# City of Alexandria, Virginia

## MEMORANDUM

**SUBJECT:** 2<sup>ND</sup> CONCEPT REVIEW OF 515 NORTH WASHINGTON STREET  
(THE COTTON FACTORY) BAR CASE # 2014-0038

Proposed Site Plan

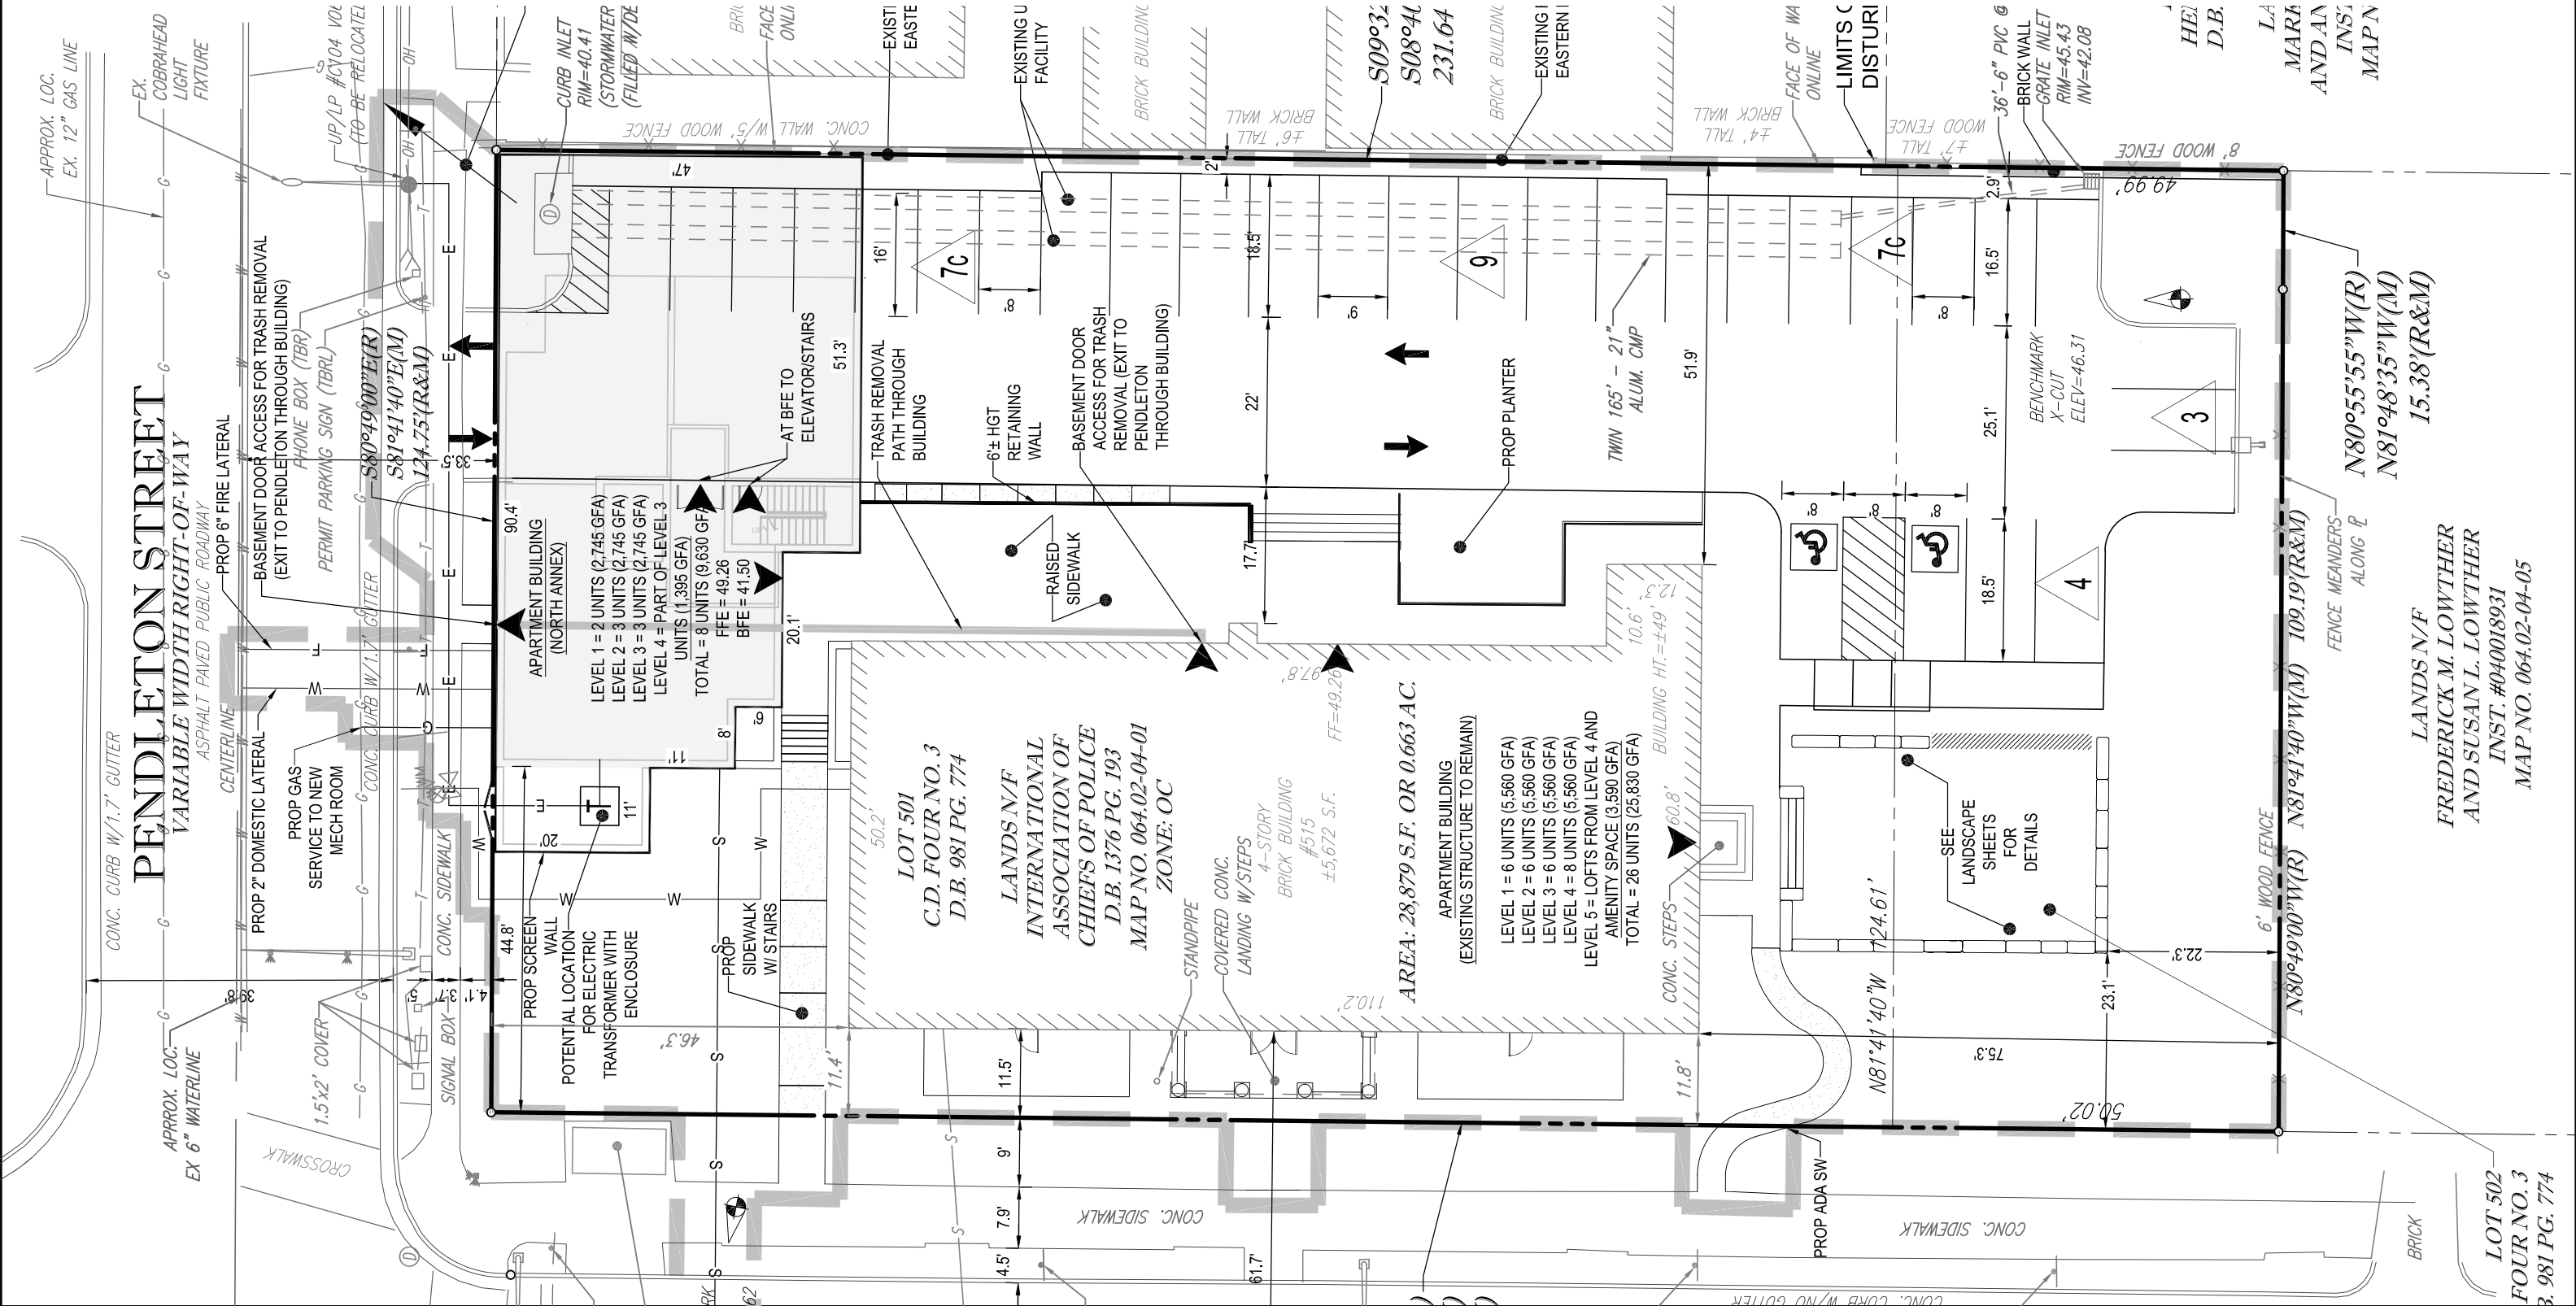
- Sheet 7: We should have T&ES confirm that the three parking spaces at the southern end of the parking lot have adequate space for backing out.
- Sheet 7: The curving ADA ramp at southern end of site leading to side entry is awkward as it does not relate well to other walkways which are much more angular.
- Sheet 7: The raised sidewalk (patio area) at the rear has a large paved surface area. Additional design needed to provide greater purpose to this area (maybe outside seating) and the addition of landscaping or planters to break up the hard surfaces.
- Sheet 7: Recommend that the private unit patios proposed on either side of the front portico be removed.
- Sheets 11, 18, 21: Planted hedge should not block the central portico on the West façade.
- Overall better coordination is needed between the landscape plan and the existing building and new building.

WEST ELEVATION

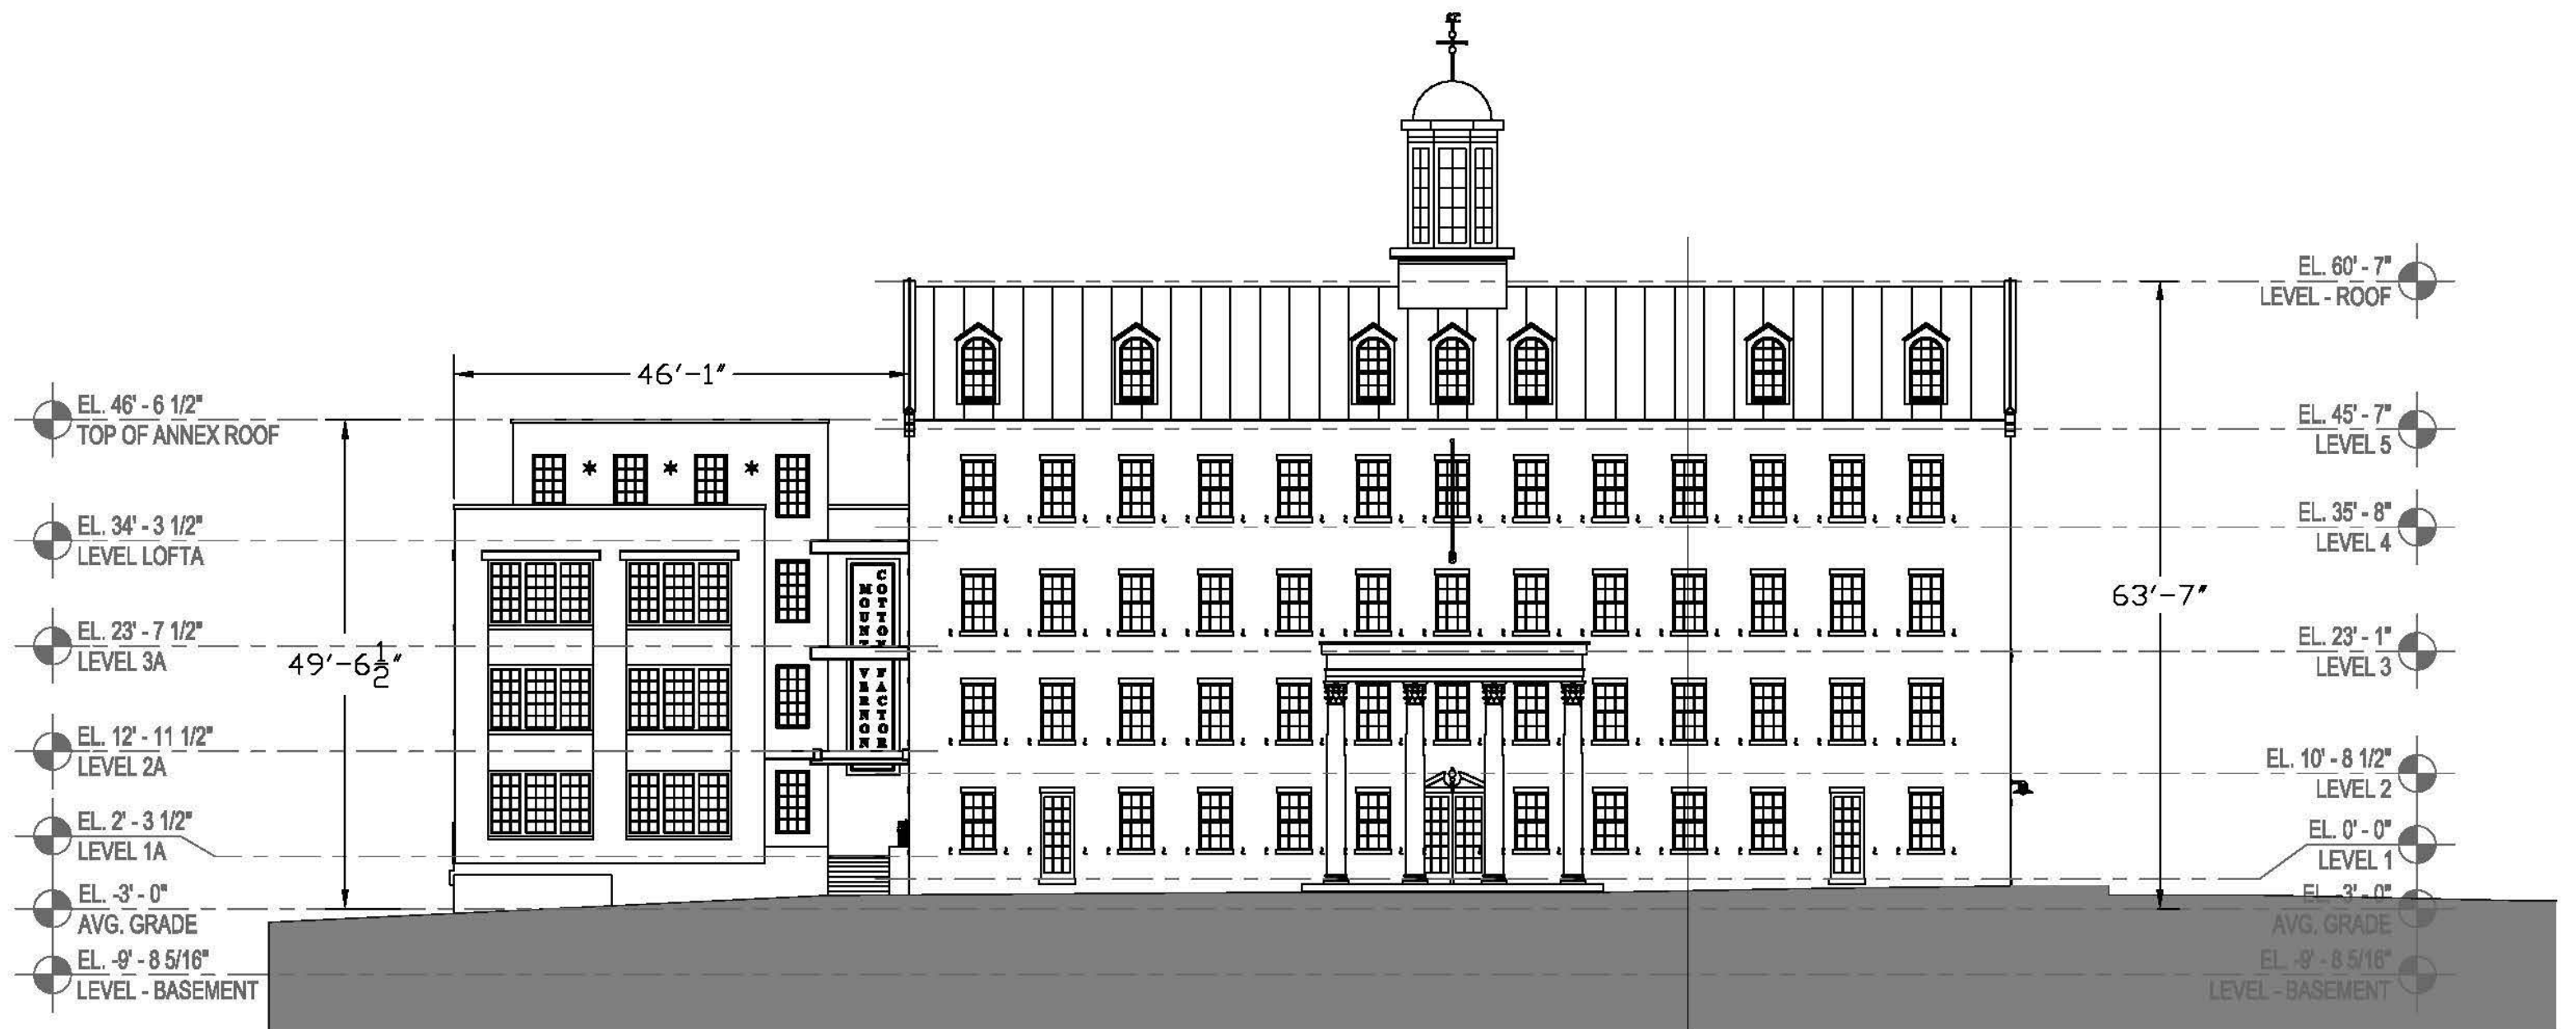
- Sheet 11: Not convinced the steel connector beams are necessary. The addition to remain detached to preserve the original building in its purest form.

- Sheet 11: The existing portico should not be blocked off by the hedge.
- Sheets 12, 25: The retaining wall between the parking lot and the rear walkway/patio area appears tall and blocky. Similarly the two planters in this area bordering either side of the rear entry are also blocky. Consider alternative design solutions.
